Discontinuation Notice of DIP Switch A6ER series.

Product Discontinuation

**Model A6ER-□101****Model A6ER-□104**

Model A6FR-□101**Model A6FR-□104**

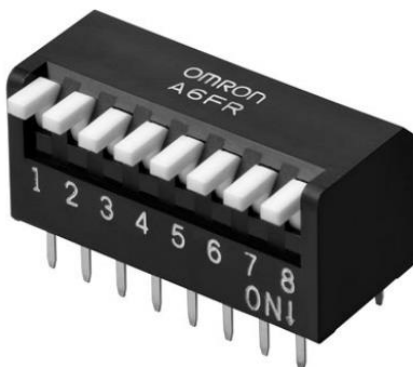
Color of actuators of A6FR series is white. (A6ER series is orange.)

[Dimensions]

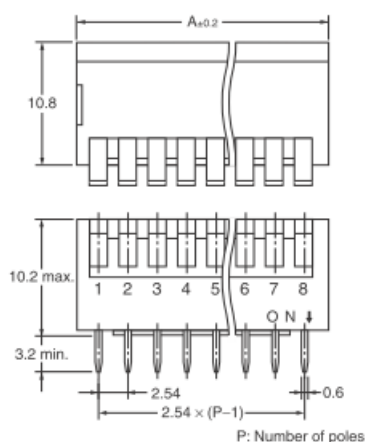
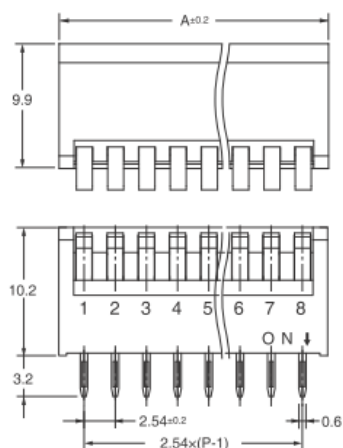
A6FR series is smaller than A6ER series.

Depth: Around 9.9 mm
